# MEMO

Date: May 24, 2013  
From: Daniel Harris  
To: All Reps  
Subject: **VAV vs. Active Chilled Beams in May ASHRAE Journal**

## **The VAV versus Active Chilled Beams + DOAS Debate. May 2013 Issue of the ASHRAE Journal.**

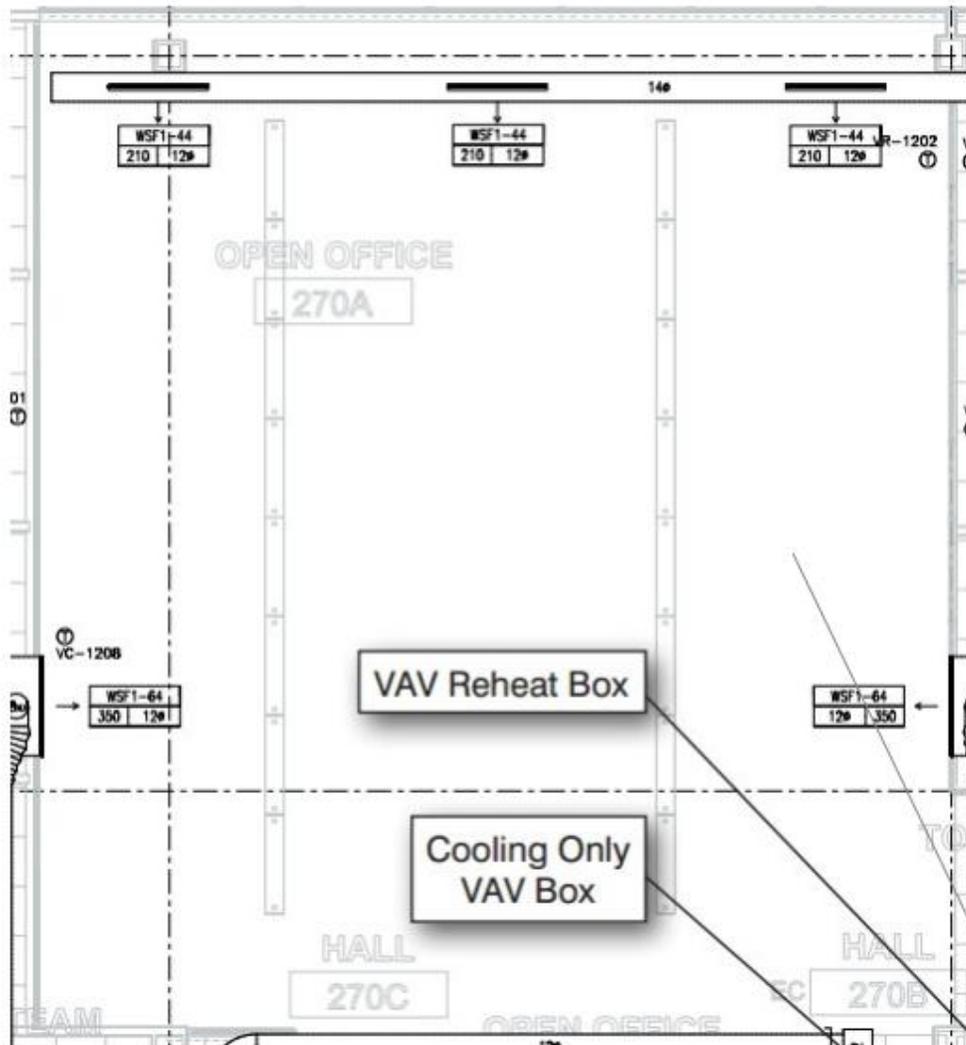
It is interesting that the authors have chosen the primary air flow rate of 0.6 CFM/ft<sup>2</sup> for this analysis. Such a high primary airflow rate is not typical for a building of this type. The high primary airflow rate is the root cause of the outcomes of this paper.

It is therefore unclear why in this paper the authors have utilized 0.6 CFM/ft<sup>2</sup> (ACB+DOAS) that can clearly be designed with approximately 0.2 CFM/ft<sup>2</sup>, suggesting a misapplication of the ACB design.

Typical chilled beam system designs are based on primary air system reduction of 65-70% compared to VAVR. This is one of the reasons that chilled beams have been proven to save energy by transferring cooling capacity from the air side to the more efficient water side system.

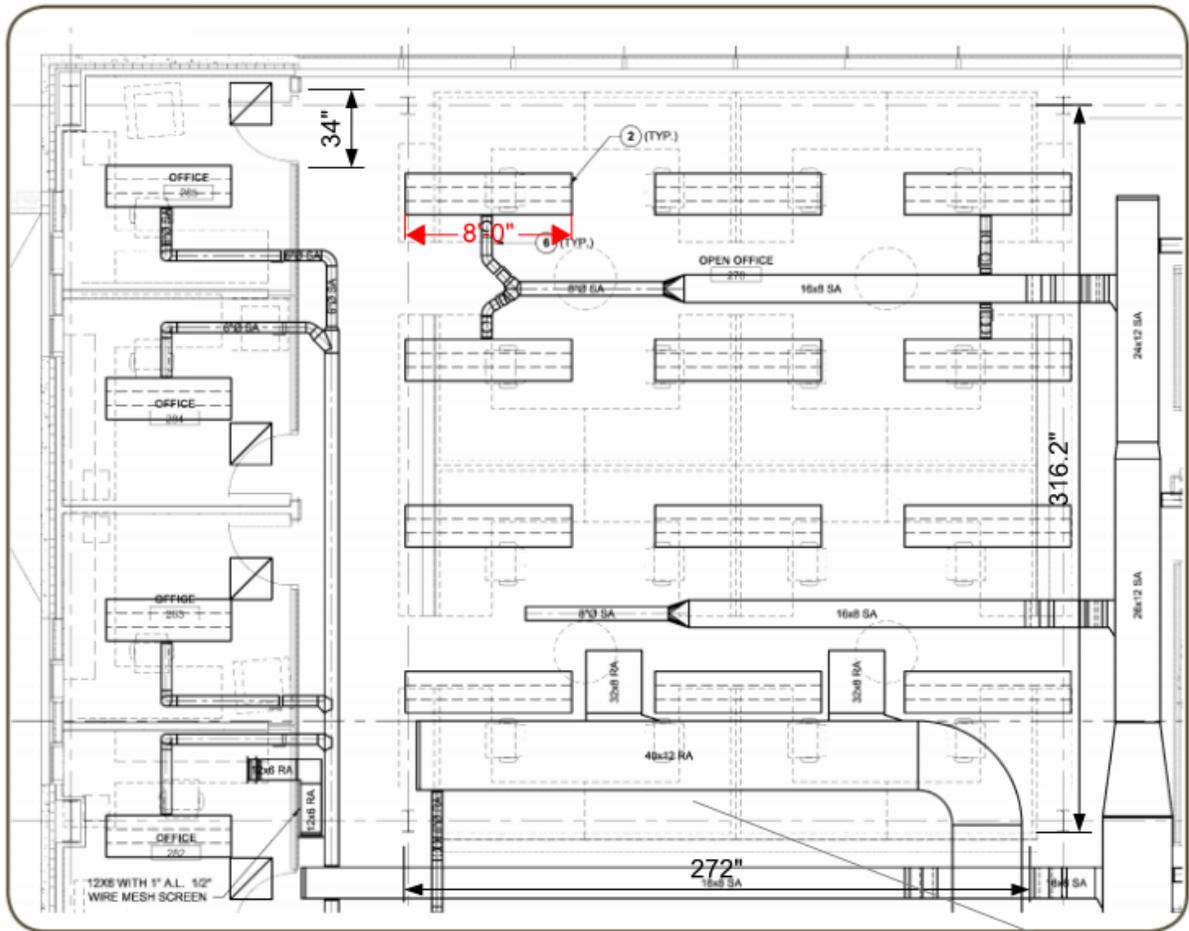
The typical floor plan shown of the subject building comprises an open plan office space. Perimeter diffusers were used for the VAVR system and a (12) 8ft long ACB's were used in the designers Chilled Beam configuration as shown below. There are some considerable errors in the ACB design layout and sizing. Had this system been designed with typical ACB design parameters, only (4) 8ft long ACB's @ 85 CFM are required to meet the load and provide adequate air distribution to the open plan office, as opposed to (12) 8ft long ACB's. This results in a total primary airflow rate of 340 CFM (0.2CFM/ft<sup>2</sup>) for the zone as opposed to 1,330 CFM (0.8 CFM/ft<sup>2</sup>) that the VAVR system requires at peak load. This 75% reduction in primary air flow rate is typical of a properly applied, well designed ACB system. To further reduce energy consumption, application of VAV units can be used to lower the primary airflow during part load conditions.

Total floorplate VAVR airflow = 1330 CFM  
Cooling load =  $1330 \times 1.08 \times 20 = 28728$

**Cooling Load = 1330 x 1.08 x 20**  
**= 28728 BTUH**  
**4 x 8' long chilled beams @ 85 CFM (340 CFM)**  
**= 26% of VAVR Airflow**

The paper claims that part load for this office building is 40% of the peak load, therefore the zone VAVR requirement would be 532 CFM (40% of 1,330 CFM) compared to 340 CFM for a constant volume ACB design, almost 65% more airflow than the ACB primary airflow rate. However, if we consider delivering the primary air to the beams using variable volume, the ACB primary air system can be turned down to the ventilation rate (120 CFM or 20 CFM per person). This again brings primary airflow of the ACB system down to 26% of the part load VAVR design.

Using the occupancy density rate of 275 ft<sup>2</sup> per person as shown in the paper, there would be approximately 6 people and a latent load of less than 1,200 BTUH (including infiltration) for the 1,600 ft<sup>2</sup> sample zone. This can be accomplished with just 90 CFM of ventilation air with a moisture content of 49.7 gr/lb if the room humidity is allowed to rise to around 54% RH.

If we now compare apples with apples, we can see that in reality the ACB+DOAS system should have been sized for a maximum primary airflow of 0.22 CFM/ft<sup>2</sup> instead of 0.6 CFM/ft<sup>2</sup>. If the beams are supplied with VAV primary air, the system could turn down to ventilation rate during part load condition which is around 0.08 CFM/ft<sup>2</sup>.
